# Access Compliance Report

## Public Rights-of-Way

### (Curb Ramps)

Intersection ID: N/A	Main Street: ELKIN_LN	Cross Street: KILBORNE_DR	Location: NW
ADA ID: 7B715D1308A4	Ramp Type: Directional1	Initial Pass/Fail: Fail	Overall Compliance: No
		Severity Score: 12.5

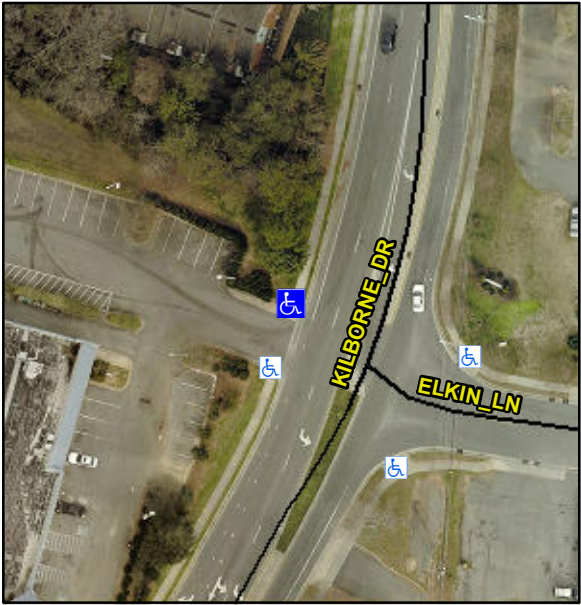
Codes/Mitigation Info/Possible Solution			Field Measurements/Component Compliance		
	Possible Solutions:		<b>Compliance</b>	<b>Description</b>	<b>Data</b>
	<b>Remove &amp; Replace Entire Ramp.</b>		N/A	Ramp Length (in)	121.0
			Yes	Ramp Width (in)	60.0
			No	Ramp Slope (%)	9.7
			Yes	Ramp XSlope (%)	1.4
			N/A	Flare Type LT	N/A
			N/A	Flare Slope LT (%)	N/A
			N/A	Flare Traversable LT?	N/A
			N/A	Flare Type RT	N/A
			N/A	Flare Slope RT (%)	0.0
<p>Surveyor Notes:</p> <p><b>N/A</b></p>			N/A	Grade Break?	N/A
			N/A	Grade Break Slope (%)	0.0
			N/A	Grade Break XSlope (%)	0.0
			N/A	Flare Type RT	N/A
			N/A	Flare Slope RT (%)	0.0
			N/A	Flare Traversable RT?	N/A
			N/A	DWS Provided?	N/A
			N/A	DWS Contrast?	N/A
			N/A	DWS Length (in)	N/A
			N/A	DWS Full Width?	N/A
<p>PROW/ADA:</p> <p><b>R304.2.2</b></p>			N/A	DWS Offset LT (in)	N/A
			N/A	DWS Offset RT (in)	N/A
			N/A	Gutter Slope (%)	N/A
			N/A	Gutter Lip Ht (in)	N/A
